Outline For Joint PAC Presentation Sarah Kelly and John Sidoti

SSD_7056

Campbell's Stores

**THE IMPACT ON THE
AMENITY OF RESIDENTS
OF 8 HICKSON ROAD**

**Campbell's Stores the southern end, where
the main kitchen exhaust is currently located**

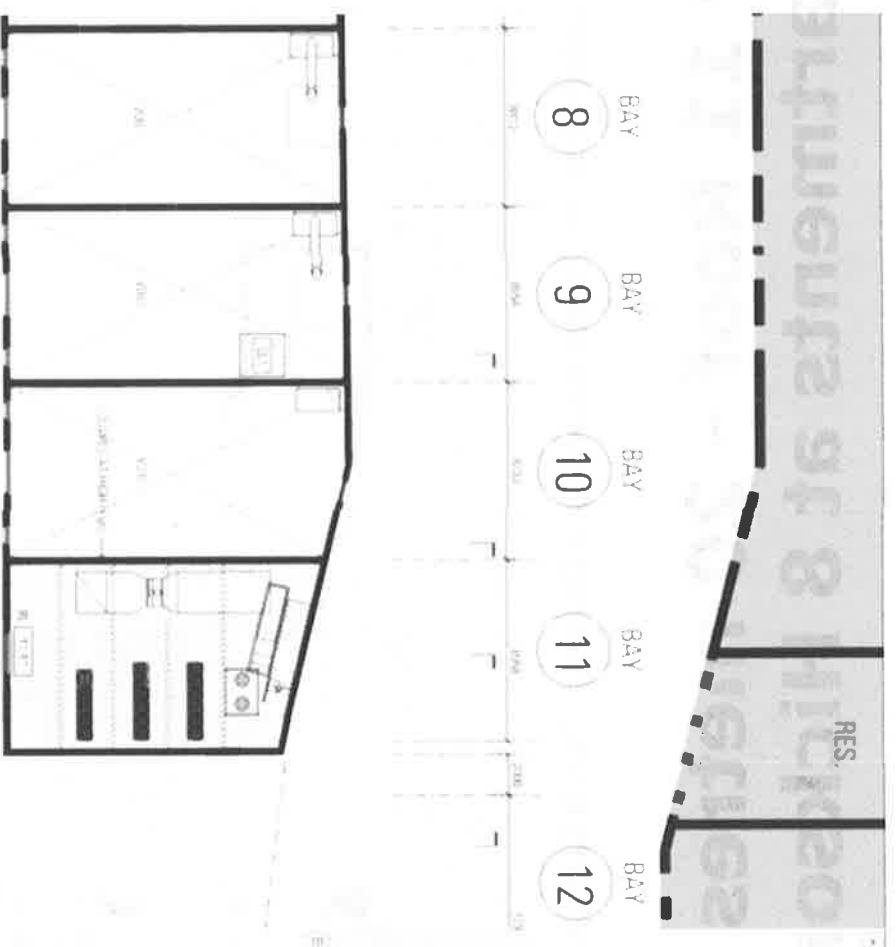
Existing locations of kitchen exhausts

Existing Kitchen exhaust Bay 7 Campbell's Stores

Source: SSD_7056 Response to Submissions Second Round Appendix A Drawings Part 1 Roof Plan Drawing No. EA-A-1006

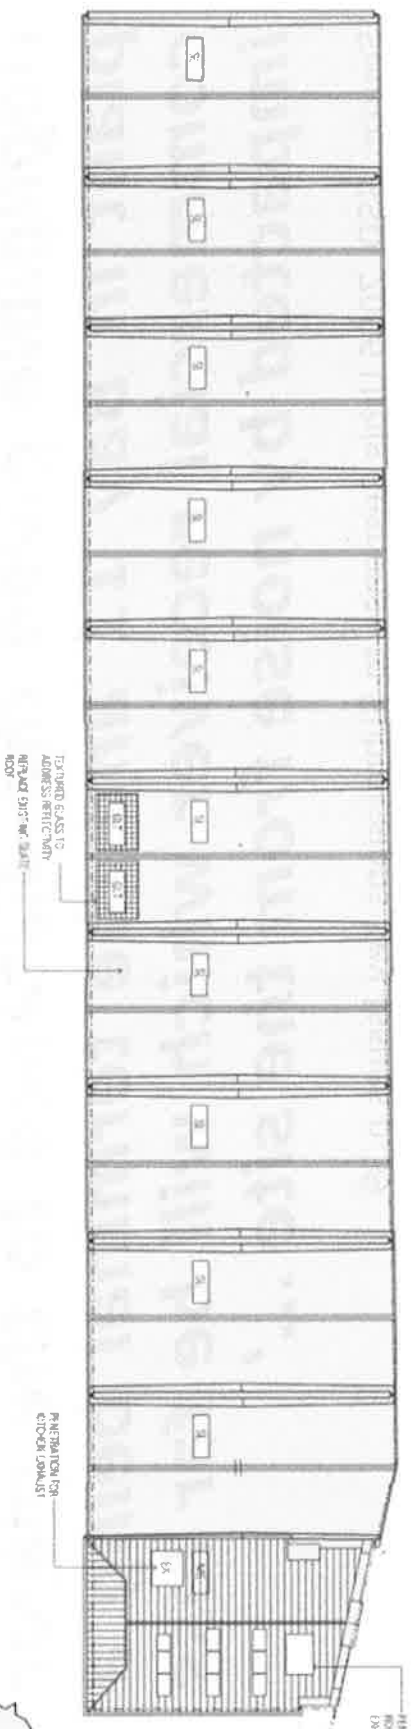
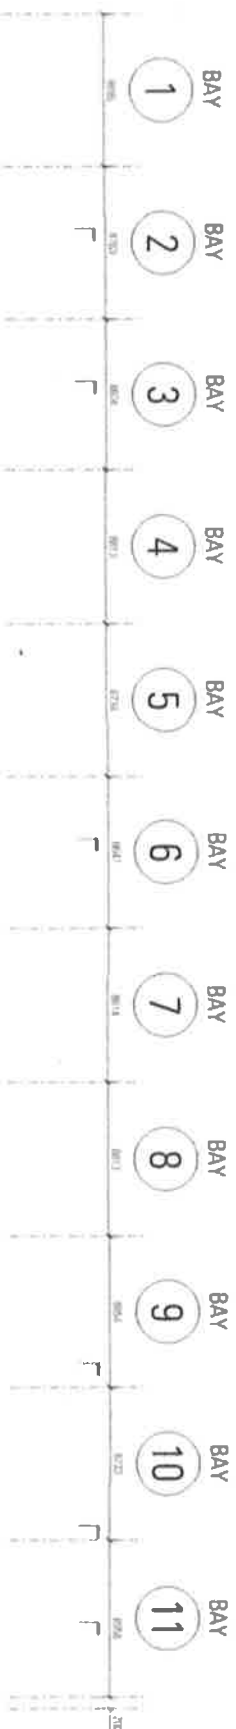
Proposed re-location of all kitchen exhaust to Bay 11

Proposed Roof Penetrations

'Mechanical noise impacts to the passenger terminal are expected to be negligible given the distance to the major plant in Bay 11 and the terminal being a commercial receiver which will be far less impacted by noise from the site ...'

- **Default noise levels.** Support the CoS by giving all tenancies a calculated maximum sound level that may be emitted from their premises.
- **No approval of the mechanical plant system within Bay 11.** Relocate to the southern and central areas of the building. Approval by the CoS in consultation with DPE.

Distance mitigates negative impact

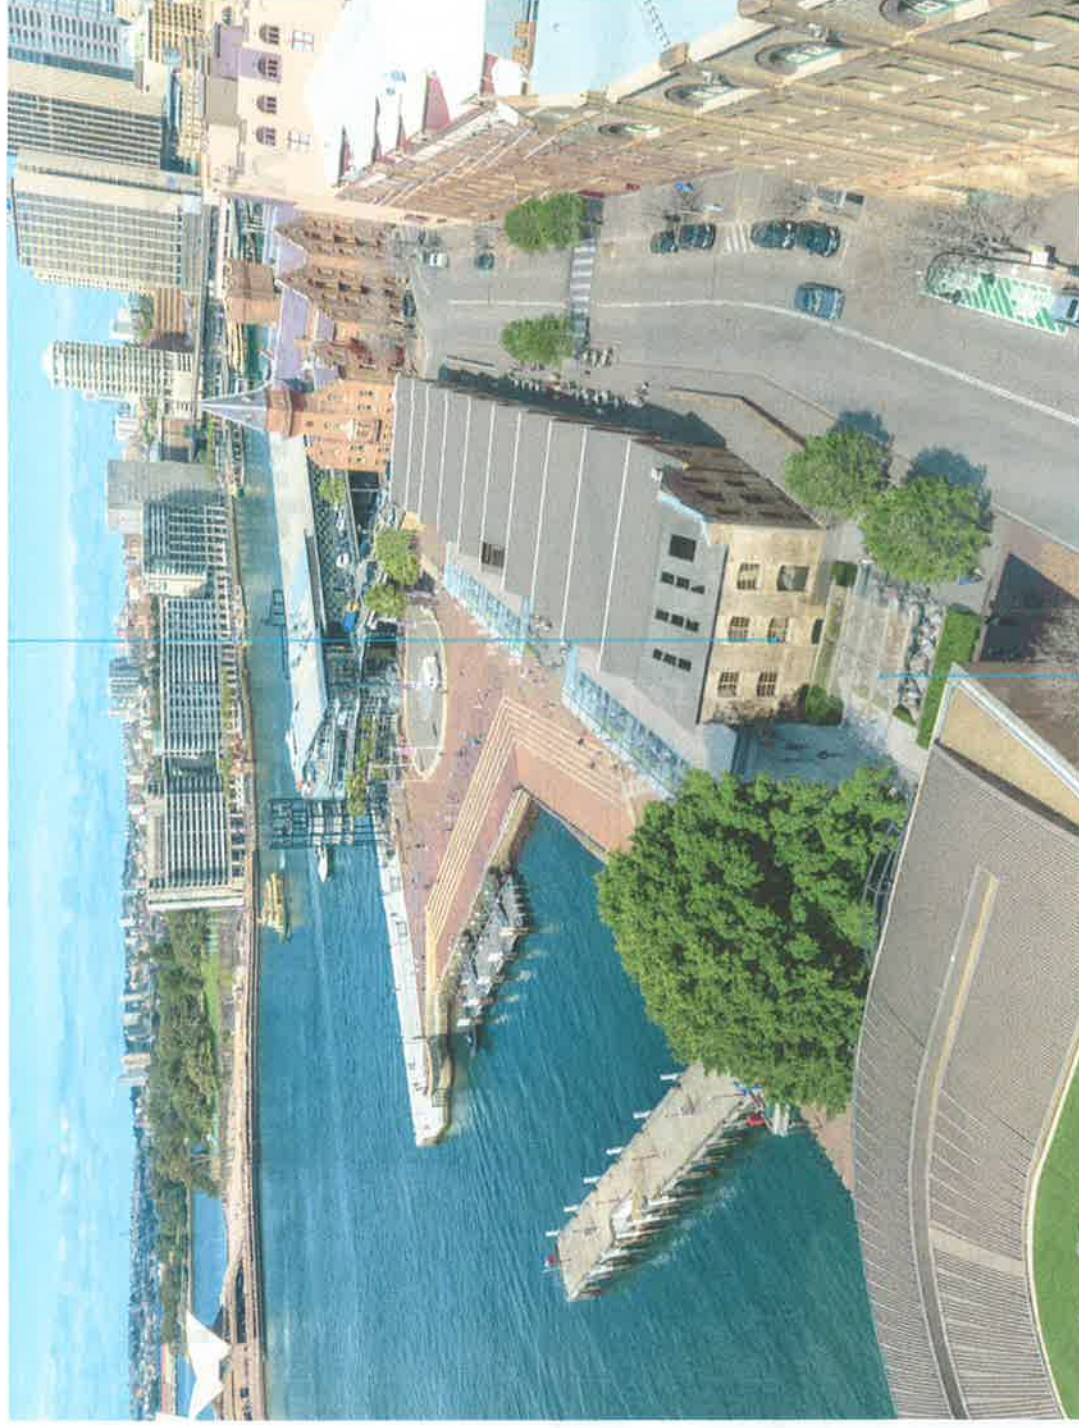
Visual Impact of mechanical exhaust at northern end

**Visual impact reduced by
locating exhaust in Bays 2-4**
